Service Note		
Product	Description:	Service note no.
BM5A Compact	Abnormal humming sound	SNo-T0155

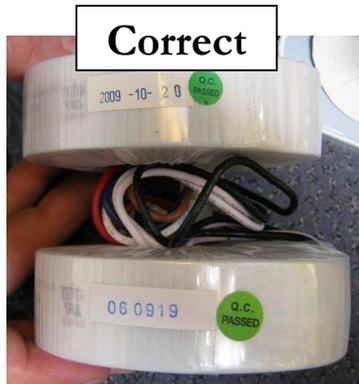
In standby mode is for some speakers detected a significant abnormal humming sound which is caused by the transformer.

The speakers that are potentially affected can be visually dissociated in "Good" and "Bad ". This is illustrated below:

The correct transformer can also be readily identified that there is a round and green "QC Passed" label and a white label with printed production date (see picture below).

Please handle as standard repairs if you get any complaints.
